The study performs the analysis of the future simulations a hydrological model driven by the hydrometeorological input obtained from the ensemble of global and regional bias corrected climate models with the goal to investigate changes in flood quantiles and flood generating processes in France.

We thank the reviewer for taking the time to review our manuscript. We hope that our responses below will help to dispel some of the misunderstandings about the manuscript, which generally call for greater clarification of the results.

Figure R1: Flood event classification, using a maximum time window of 30 days, instead of 7 days, to classify floods.

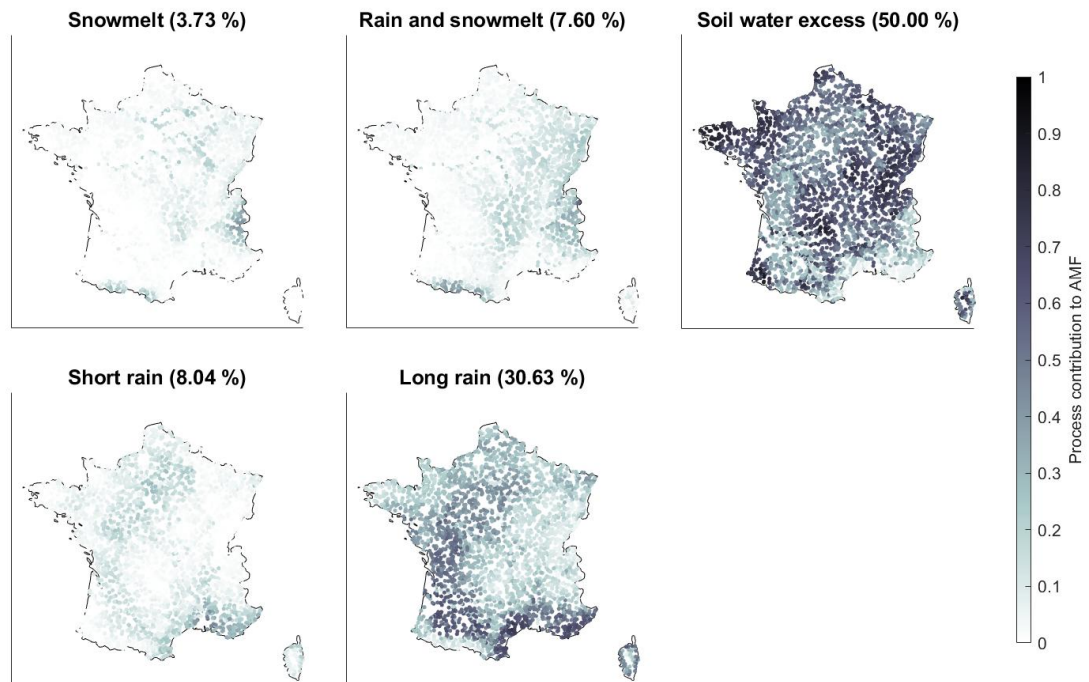
Line 233-235: It might be warranted to search for the precipitation within 7 days before the start of the event to account for the time of concentration given the size of the study catchments, but it provides little justification for such search window relative to the flood peak, as in this case such search window represents not the time of concentration but the duration of corresponding rainfall or snowmelt event. This could be especially a limiting factor for snowmelt events, where build up time can be particularly long. Hence this potentially can lead to misclassification between “Rain and snowmelt events” and the rainfall events. A designated sensitivity analysis might shed light on the effect of the window search on the classification results.

We would like to stress that this search window of 7 days is fully consistent with many published studies related to floods. In Ivancic and Shaw, 2015, they analyze the link between rainfall and floods in 390 basins and found that 93% of sites had a lag between precipitation and discharge less than 5 days. Stein et al 2019 also used a search window of 7 days in 4155 catchments worldwide. In Berghuijs et al. (2016) for 420 catchments in the United States that, it varies between 3 and 10 days, so they decided to set it to 7 days. Do et al. 2020 also used 5 days for 671 catchments across the USA.

In addition, we tested in our methodology a time window of 30 days instead of 7 days. See the results below. In Figure R1 you can see the different flood event classes, with a very similar classification as when using a maximum 7-day search window. The snowmelt event represents a small proportion at the scale of France, 3.73% if considering 30 days and 3.08% if considering 7 days as in our previous results. Similarly, the Rain and snowmelt event account for 7.60% of event when considering 30 days, 7.40% when considering 7 days. In figure R2, the changes in the different flood generation mechanisms are plotted, using a 30-day maximum search windows, with results almost identical to the results presented in the manuscript.

Consequently, we kept the 7-day time window.

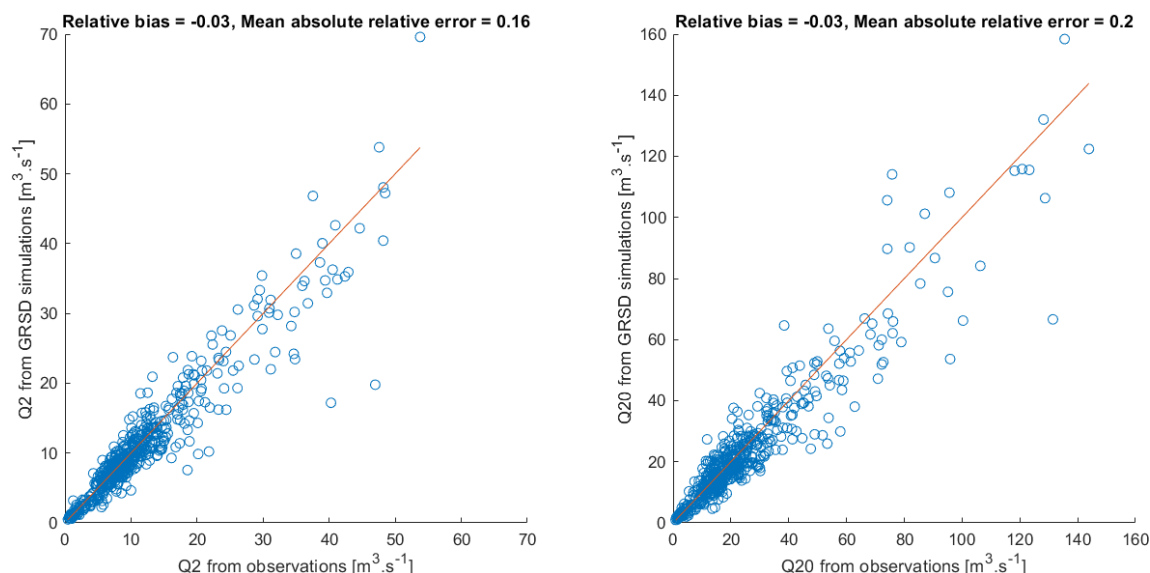
Line 295-297: Although this study aims to analyze trends in the 2 and 20-year return period floods, the performance of the model chain is not shown neither for representing past floods with different return periods nor for representing their changes in the past. Please also see my major comment.

We agree. Even if the references of Sauquet et al. 2024, 2025, are presenting a complete validation of the modelling chain on many indicators indicating mean flow, extremes... we added the comparison of the 2-year (Q2) and 20-year (Q20) quantiles between the observations and the hydrological model. Please see the figure R3 below. As shown on figure R3, the mean error is equal to 16% for Q2 and 20% for Q20, that could be considered low given that we are dealing here with extreme values. We added this figure in supplementary materials.

About representing changes in flood in the past, it is not feasible given the short time period (1975-2005) that prevent a robust assessment. Climate models that are not driven by reanalysis data but CMIP simulations are not able to reproduce an accurate day-to-day chronology (given the impact of internal variability and model initialization), so they are not fit for the purpose of identifying past trends (Randall et al. 2007, Scinocca et al., 2015), notably on short time periods (this is why in the present manuscript we do the trend detection on the full time series 1975-2100).
